City of Alachua

Staff Report

SUBJECT:	A request for consideration of the final plat of Tara Forest East Phase 1 , which proposes the subdivision of a ±10.86 acre subject property into a total of 32 single family detached lots, with associated right-of-way and common areas
APPLICANT/AGENT:	Kyle Williems, P.E. of JBPro, Inc.
PROPERTY OWNER:	Tara Forest, LLC
LOCATION:	West of CR 241, north of Baywood Subdivision
PARCEL ID NUMBERS:	03067-005-001, 03067-000-000, and 03067-005-000
FLUM DESIGNATION:	Moderate Density Residential
ZONING:	Residential Single Family- 3 (RSF-3)
OVERLAY:	NA
ACREAGE:	±10.86 acres
PROJECT PLANNER:	Adam Hall, AICP, Principal Planner
RECOMMENDATION:	Staff recommends that the City Commission: <ol style="list-style-type: none">1. Approve the Final Plat of Tara Forest East Phase 1 (“Final Plat”);2. Approve the “Subdividers Agreement for Tara Forest East Phase 1” (“Subdividers Agreement”);3. Authorize the Mayor and City Attorney to sign the Final Plat and Subdividers Agreement; and,4. Accept the Common Law Performance Bond from Tara Forest, LLC in the amount of \$2,031,847.43 as the surety instrument for infrastructure improvements, other than the house sidewalks; and

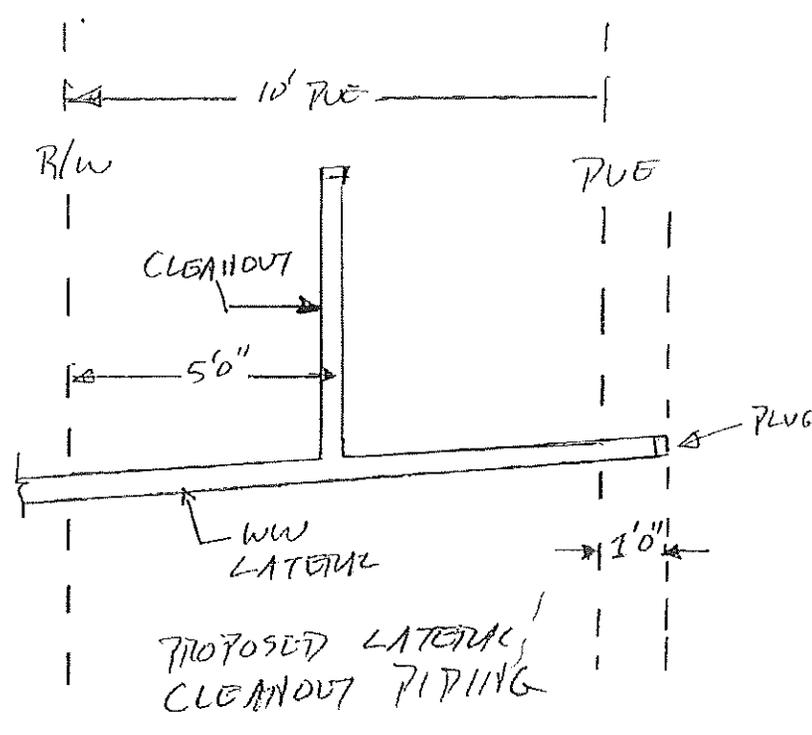
6.	<p>Comment on April 2021 Plans Sheet C6.00 Call out “END COA MAINTENANCE” for both wastewater cleanout and water meter. Distance between trees and water main is a called out as 9 feet. Please change to 10 feet to comply CoA DCM. Sheets C6.03 – C6.08 On each of these sheets, also call out “END COA MAINTENANCE”, one typical for the water meter & one typical for the cleanout. Comment on June 2021 Plans</p>

NO.	COMMENTS
	<p>The distance between trees and water mains is now shown as 10 feet. In a review of the landscaping sheets, distances between trees and mains appear to be less than this. The reviewer has scaled off the following distances between trees and mains: (1) L-205, 7.5' (2) L-204, 9.2' (3) L-205, 8.6' & (4) L-206, 9.2'. Please confirm with the landscape designer that the minimum distance between water mains and trees is 10 feet. This may be a sheet scaling issue.</p> <p>Also, the cleanout is shown at the terminus of the PUE. Please relocate so that it is in the middle of the PUE. This is mostly because, if future excavation of the PUE is needed, the excavated hole remains within the confines of the PUE.</p> <p>To facilitate installation of utilities such as CATV in the PUE, extend the wastewater lateral to 1 foot beyond the PUE, and cap it. See proposed sketch below.</p>  <p>Submit response and applicable sheets.</p> <p>Comment on Oct 2021 Plans</p> <p>The minimum distance between trees and water mains is acceptable.</p> <p>The design engineer has indicated a preference (as well as reasons for this preference) that the cleanout be located at the edge of the PUE. CoA suggests that this issue be discussed ASAP.</p> <p>Reasons for the CoA preference that the cleanout be located in the middle of the PUE include:</p>

NO.	COMMENTS
	<ul style="list-style-type: none"> • Based upon a recent construction project, locating the cleanout at the edge of the PUE caused interference problems in routing the lateral from the COA cleanout to the house cleanout. As a field change, the PUE was moved back to the middle of the PUE. It should be noted that this issue was exacerbated by the short front setback distance. Tara Forest East may have a longer front setback distance. • To remove a defective cleanout, excavation at a typical slope of 1:1 will be required. If the cleanout is 3-foot deep, a 3-foot horizontal excavation on the owner's property NOT in the PUE will be required. CoA preference is to avoid this situation. • If the cleanout is located in the middle of the PUE, it will be one of the first utilities installed. Typical utilities installed in the middle of the PUE include communications and TV cable. Such utilities typically are small diameter cable and are installed at a shallow depth. It is expected that the cleanout in the middle of the PUE will not interfere with the installation of such utilities. <p>Comments on November 2021 Documents</p> <p>For this specific project, CoA takes no exception to locating the cleanout at the edge of the PUE.</p> <p>Approved</p>

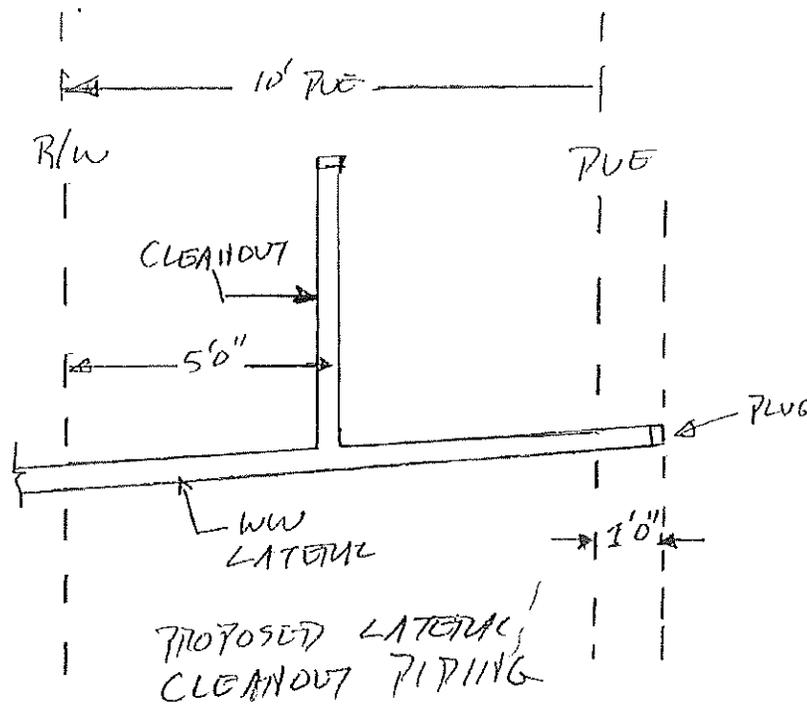
6.	<p>Comment on April 2021 Plans</p> <p>Sheet C6.00</p> <p>Call out “END COA MAINTENANCE” for both wastewater cleanout and water meter.</p> <p>Distance between trees and water main is a called out as 9 feet. Please change to 10 feet to comply CoA DCM.</p> <p>Sheets C6.03 – C6.08</p> <p>On each of these sheets, also call out “END COA MAINTENANCE”, one typical for the water meter & one typical for the cleanout.</p> <p>Comment on June 2021 Plans</p>

The distance between trees and water mains is now shown as 10 feet. In a review of the landscaping sheets, distances between trees and mains appear to be less than this. The reviewer has scaled off the following distances between trees and mains: (1) L-205, 7.5' (2) L-204, 9.2' (3) L-205, 8.6' & (4) L-206, 9.2'. Please confirm with the landscape designer that the minimum distance between water mains and trees is 10 feet. This may be a sheet scaling issue.

Also, the cleanout is shown at the terminus of the PUE. Please relocate so that it is in the middle of the PUE. This is mostly because, if future excavation of the PUE is needed, the excavated hole remains within the confines of the PUE.

To facilitate installation of utilities such as CATV in the PUE, extend the wastewater lateral to 1 foot beyond the PUE, and cap it. See proposed sketch below.

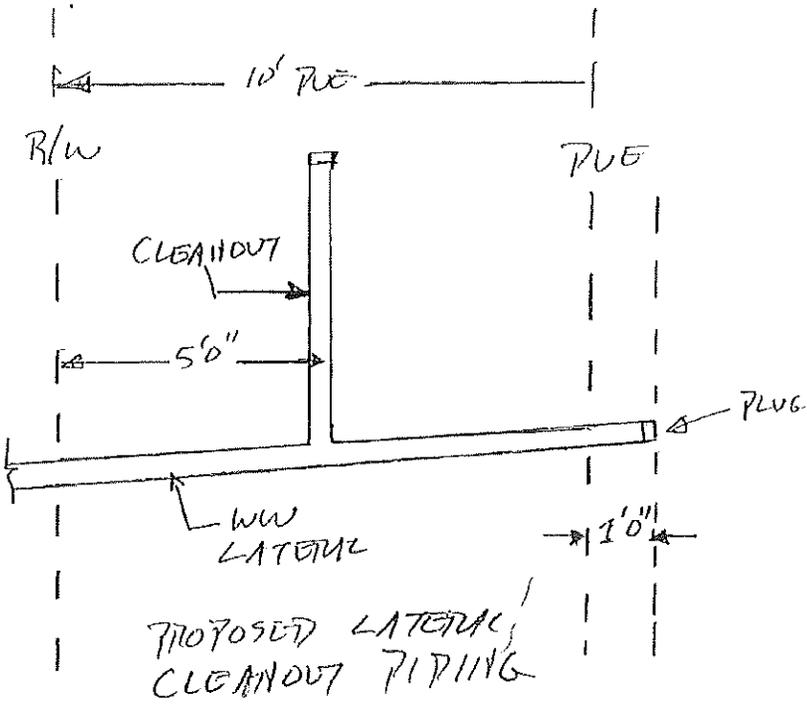
6.	<p>Comment on April 2021 Plans</p> <p>Sheet C6.00</p> <p>Call out “END COA MAINTENANCE” for both wastewater cleanout and water meter.</p> <p>Distance between trees and water main is a called out as 9 feet. Please change to 10 feet to comply CoA DCM.</p> <p>Sheets C6.03 – C6.08</p> <p>On each of these sheets, also call out “END COA MAINTENANCE”, one typical for the water meter & one typical for the cleanout.</p> <p>Comment on June 2021 Plans</p>

NO.	COMMENTS
	<p>The distance between trees and water mains is now shown as 10 feet. In a review of the landscaping sheets, distances between trees and mains appear to be less than this. The reviewer has scaled off the following distances between trees and mains: (1) L-205, 7.5' (2) L-204, 9.2' (3) L-205, 8.6' & (4) L-206, 9.2'. Please confirm with the landscape designer that the minimum distance between water mains and trees is 10 feet. This may be a sheet scaling issue.</p> <p>Also, the cleanout is shown at the terminus of the PUE. Please relocate so that it is in the middle of the PUE. This is mostly because, if future excavation of the PUE is needed, the excavated hole remains within the confines of the PUE.</p> <p>To facilitate installation of utilities such as CATV in the PUE, extend the wastewater lateral to 1 foot beyond the PUE, and cap it. See proposed sketch below.</p>  <p>Submit response and applicable sheets.</p> <p>Comment on Oct 2021 Plans</p> <p>The minimum distance between trees and water mains is acceptable.</p> <p>The design engineer has indicated a preference (as well as reasons for this preference) that the cleanout be located at the edge of the PUE. CoA suggests that this issue be discussed ASAP.</p> <p>Reasons for the CoA preference that the cleanout be located in the middle of the PUE include:</p>

NO.	COMMENTS
	<ul style="list-style-type: none"> • Based upon a recent construction project, locating the cleanout at the edge of the PUE caused interference problems in routing the lateral from the COA cleanout to the house cleanout. As a field change, the PUE was moved back to the middle of the PUE. It should be noted that this issue was exacerbated by the short front setback distance. Tara Forest East may have a longer front setback distance. • To remove a defective cleanout, excavation at a typical slope of 1:1 will be required. If the cleanout is 3-foot deep, a 3-foot horizontal excavation on the owner's property NOT in the PUE will be required. CoA preference is to avoid this situation. • If the cleanout is located in the middle of the PUE, it will be one of the first utilities installed. Typical utilities installed in the middle of the PUE include communications and TV cable. Such utilities typically are small diameter cable and are installed at a shallow depth. It is expected that the cleanout in the middle of the PUE will not interfere with the installation of such utilities. <p>Comments on November 2021 Documents</p> <p>For this specific project, CoA takes no exception to locating the cleanout at the edge of the PUE.</p> <p>Approved</p>
